Evaluation of three as-built aLigo optical levers at LHO: PR3, HAM2, ITMY

Cheryl Vorvick
Optical Lever Acceptance Review
LHO
6/6/2013
T1300651-v1

ITMY OpLev Receiver Housing

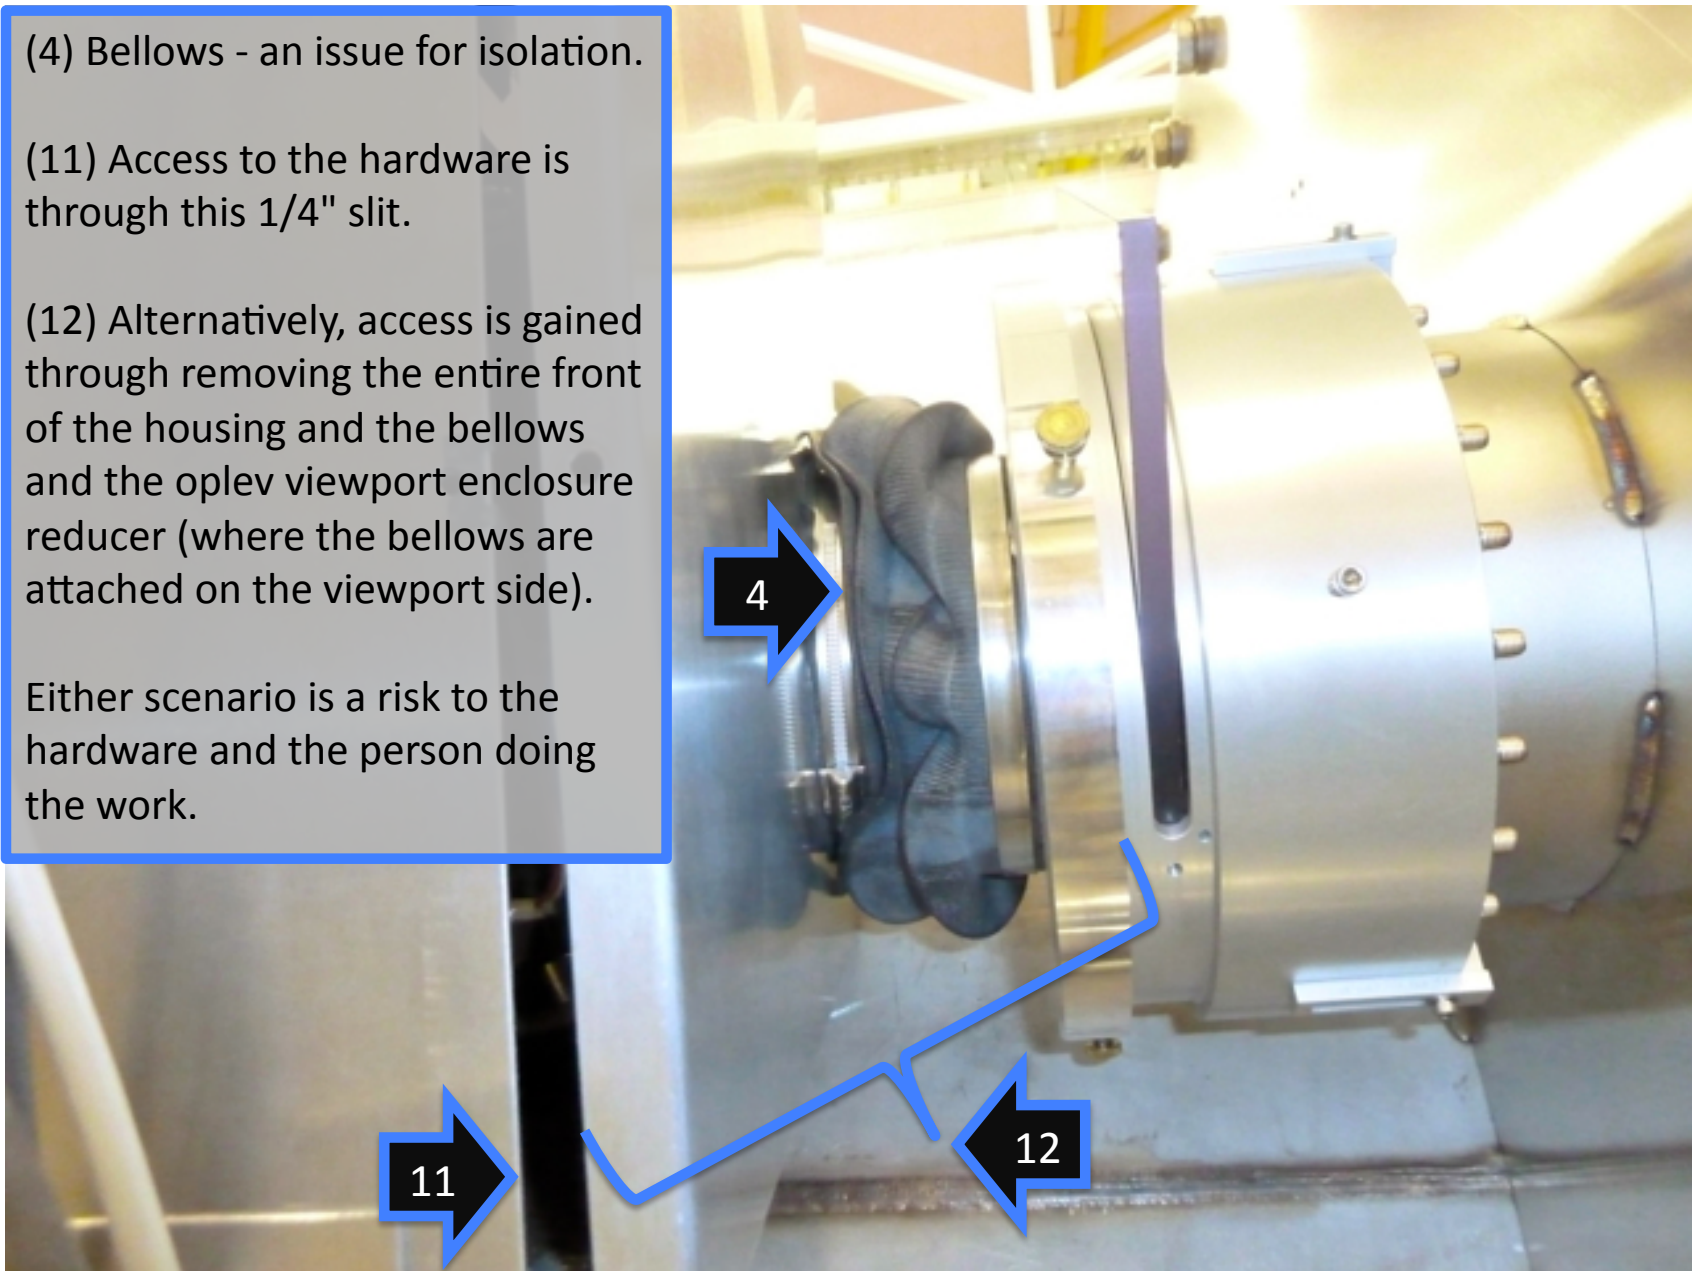
(4) Bellows - an issue for isolation.

(11) Access to the hardware is through this 1/4" slit.

(12) Alternatively, access is gained through removing the entire front of the housing and the bellows and the oplet viewport enclosure reducer (where the bellows are attached on the viewport side).

Either scenario is a risk to the hardware and the person doing the work.

(13a) View through the slit.

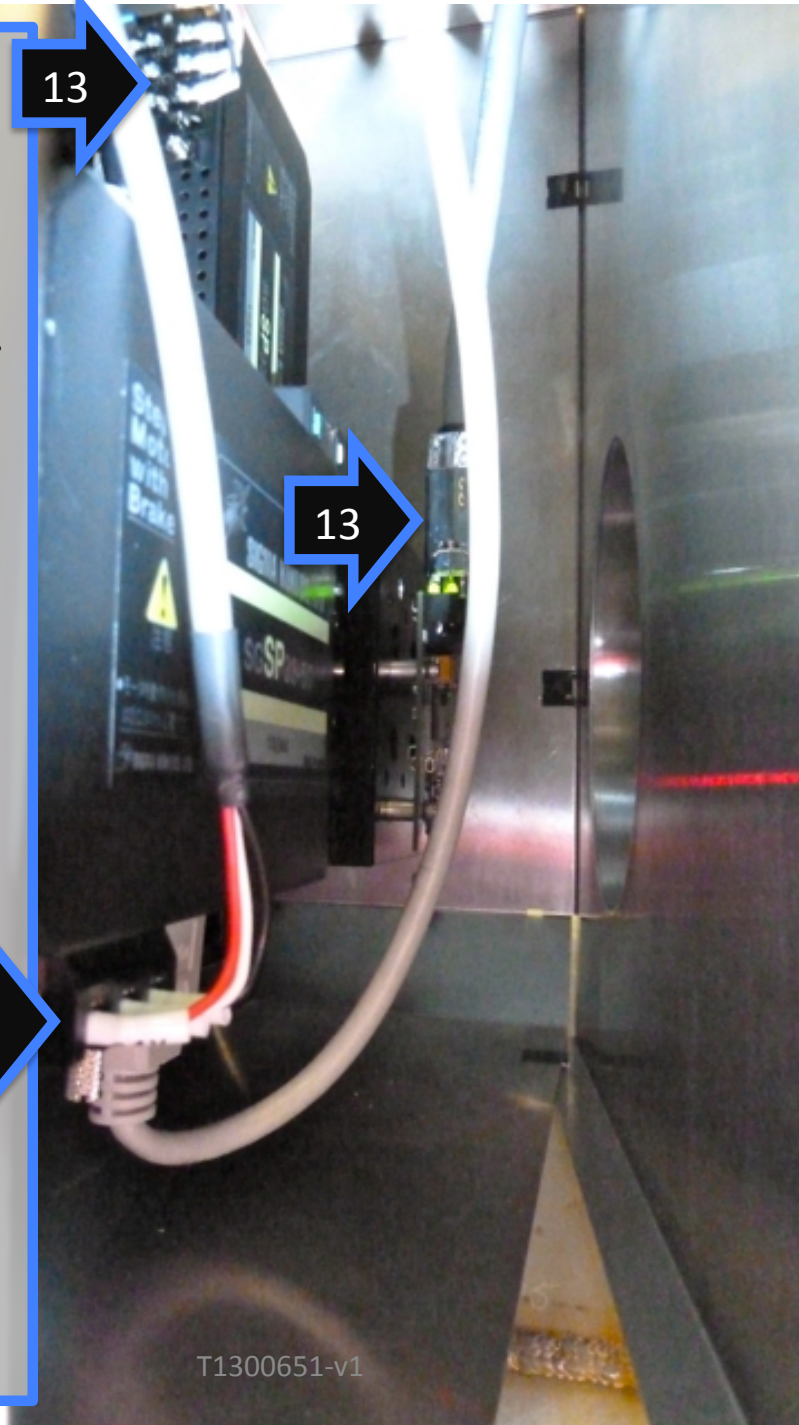
Note the exposed raised circuit board, two sets of wires that come in at a 90 degree angle to the cable path, and a connector that is 180 degrees from the cable path. Contact with cables is unavoidable, which puts the cable connections at risk.

The cables make the back part of the box minimally accessible, and any attempt to work in the box means contact with the stepper motor and it's cables, which will change the alignment of the receiver.

The stepper motor cables themselves are a tether and alter the position of the receiver.

(13b) View through the slit.

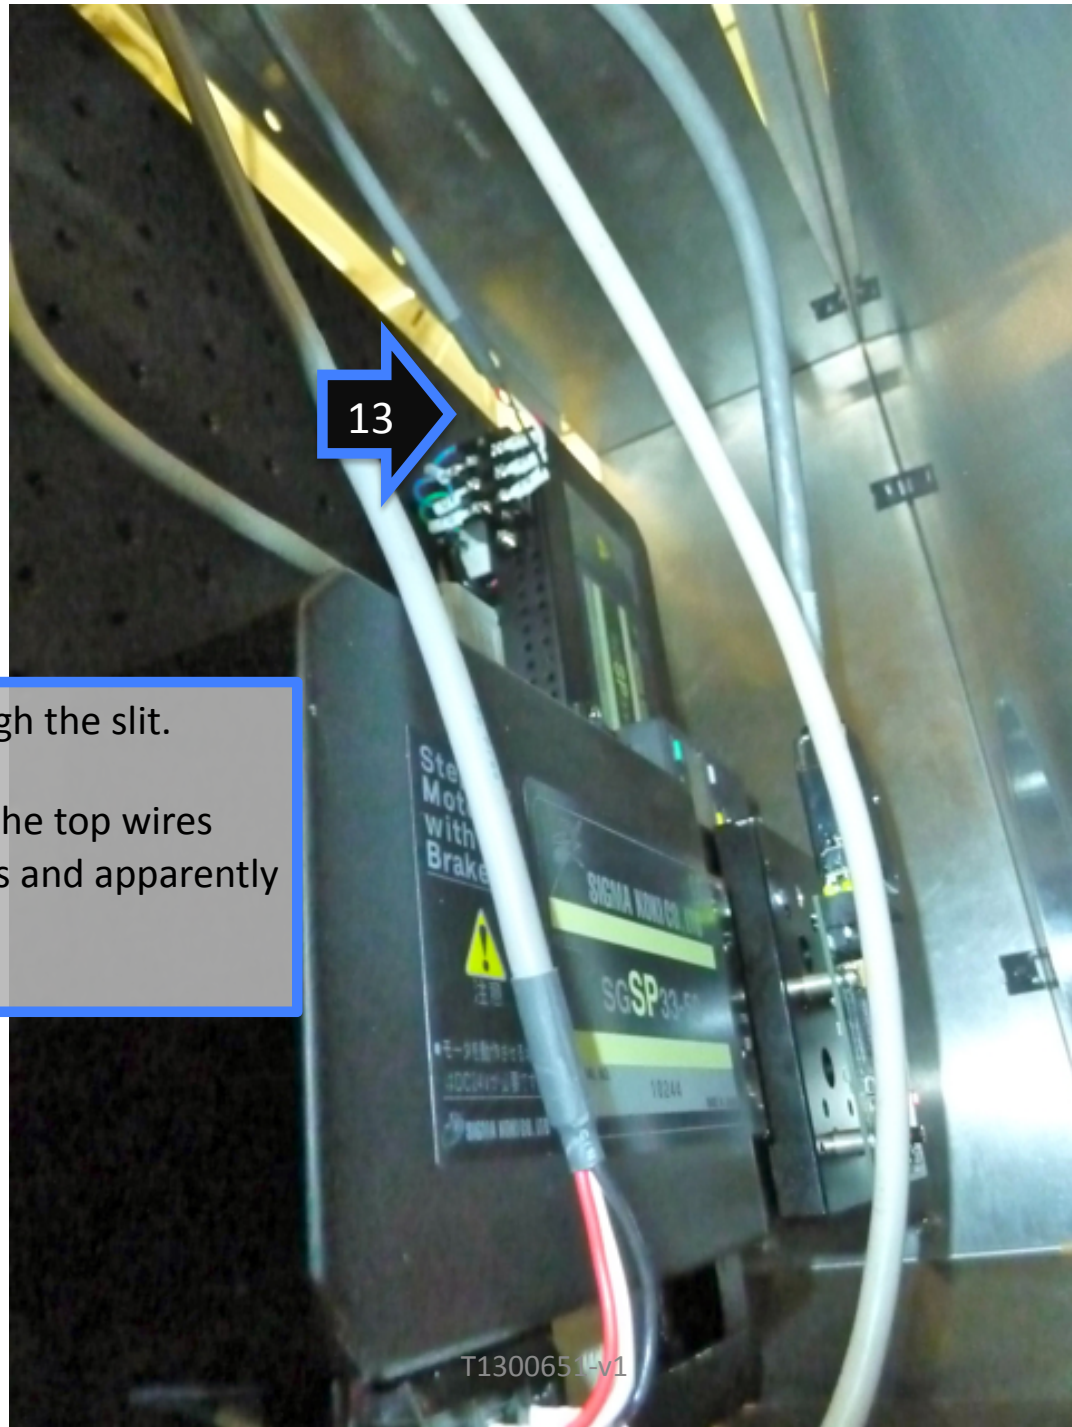
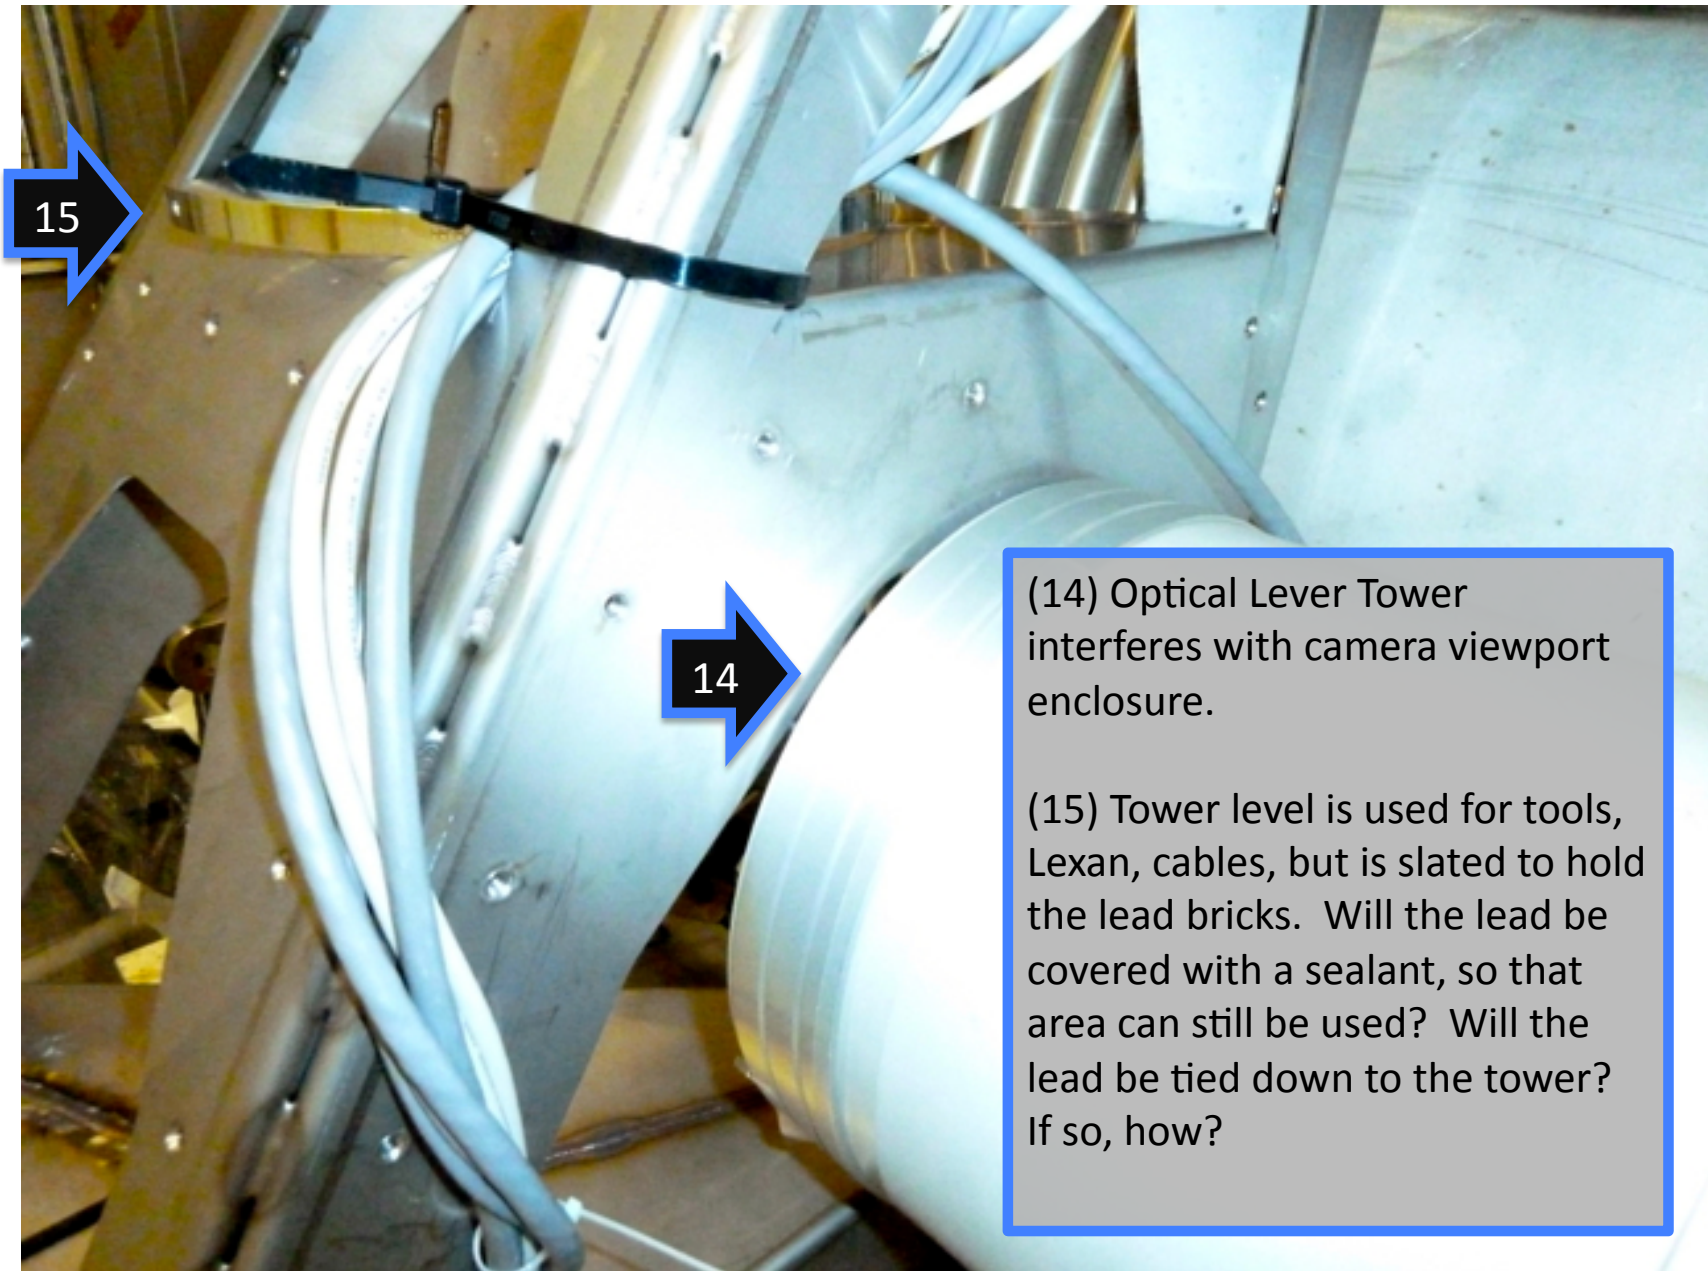
A better view of the top wires folded 90 degrees and apparently under tension.

(14) Optical Lever Tower interferes with camera viewport enclosure.

(15) Tower level is used for tools, Lexan, cables, but is slated to hold the lead bricks. Will the lead be covered with a sealant, so that area can still be used? Will the lead be tied down to the tower? If so, how?

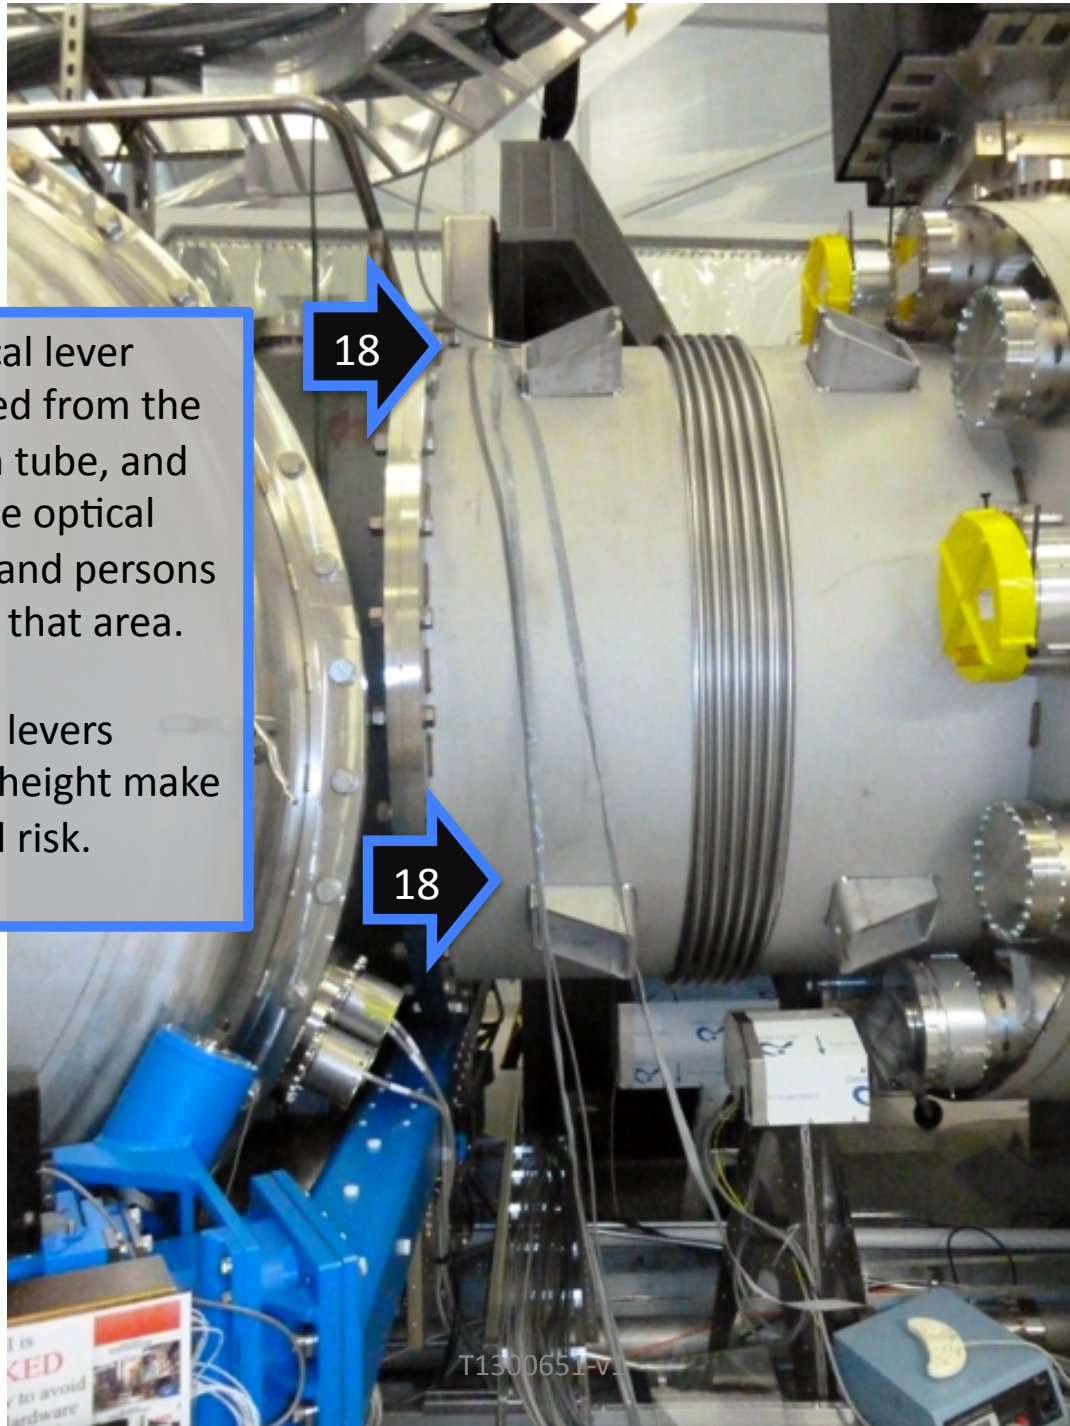
(16) The controller used to center the QPDs is bulky and must be carried to each optical lever, plugged in, and disconnected, every time an optical lever needs to be centered.

This is a risk to hardware and a risk that an off-center optical lever will remain off-center due to limited access, degrading its performance.

Additionally, connecting and disconnecting (or turning on and off) the control box moves the pointing in an unpredictable way.

(17) What tests have been done to show how often centering will be needed?

Do the tests support the belief that centering does NOT need to be handled from the Control Room?

(18) These optical lever cables are draped from the top of the beam tube, and pose a risk to the optical lever hardware and persons working around that area.

Multiple optical levers installed at this height make this a non-trivial risk.
